Fwd: comment for Rollins road traffic calming

Rollins Road Traffic Calming

Rollins Road Traffic Calming

ROLLINS ROAD TRAFFIC CALMING

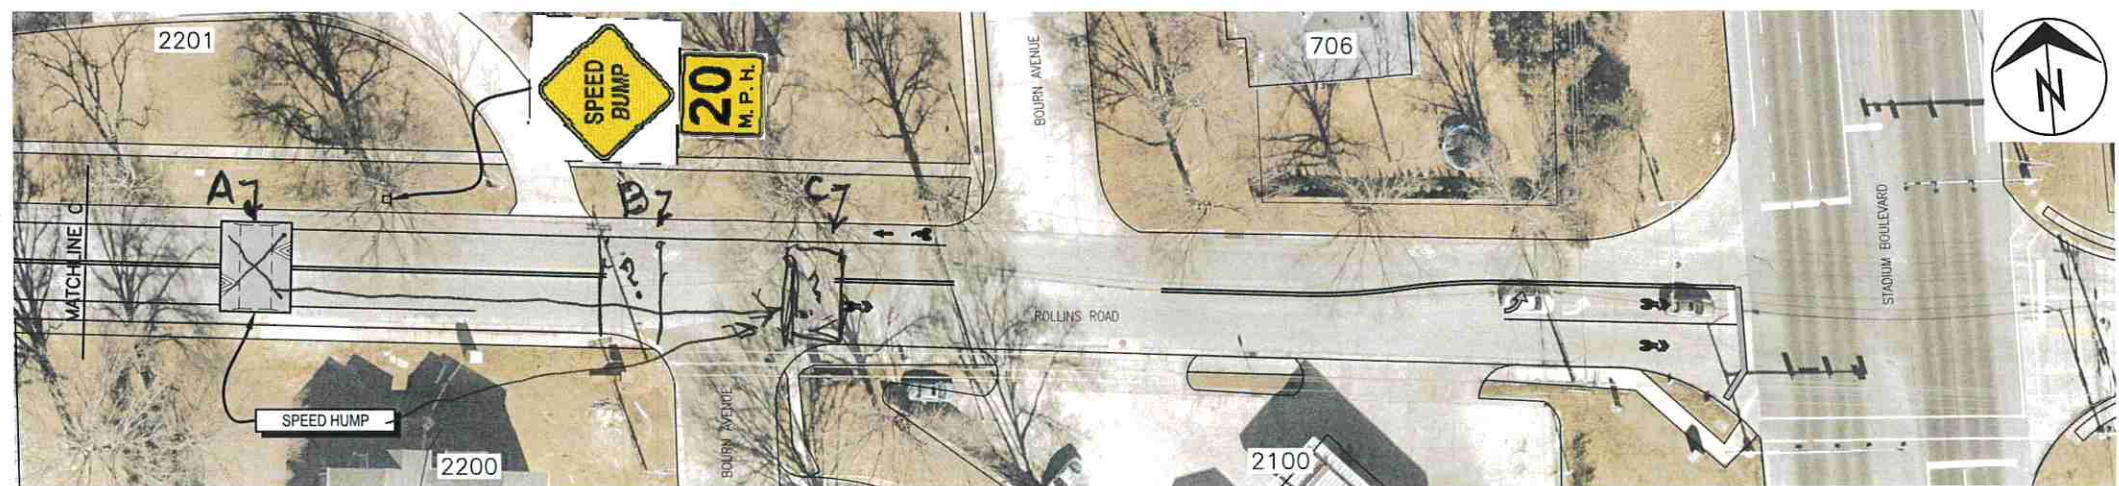
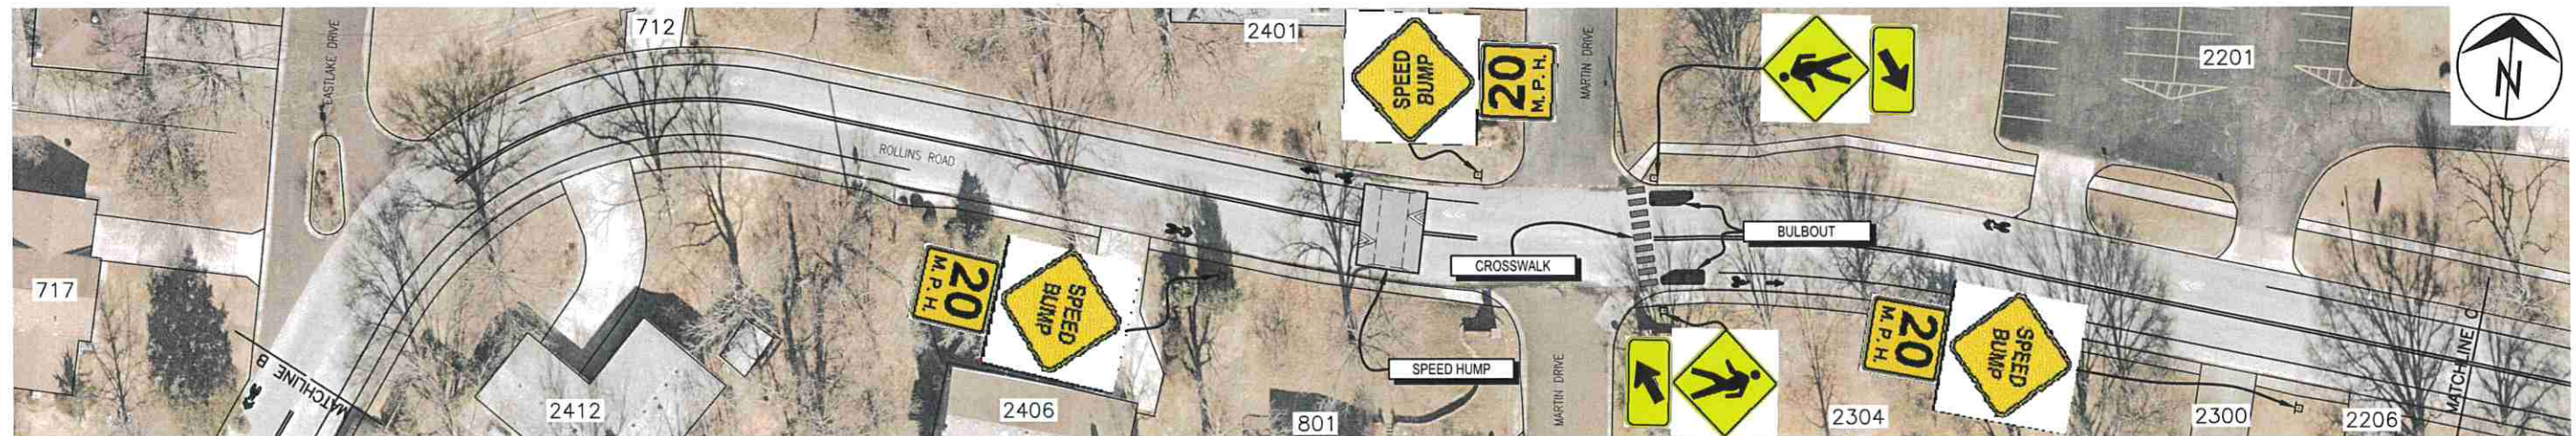
Western & Center speed humps seem appropriately located.
I wonder if the easternmost speed bump might be more effective if moved eastward a bit

WOULD MOVING SPEED HUMP (NOW PROPOSED AT "A") TO LOCATION "B" OR "C" EFFECTIVELY SLOW SPEEDS ON ROLLINS FROM BOTH DIRECTIONS?
 jim.loveless49@gmail.com
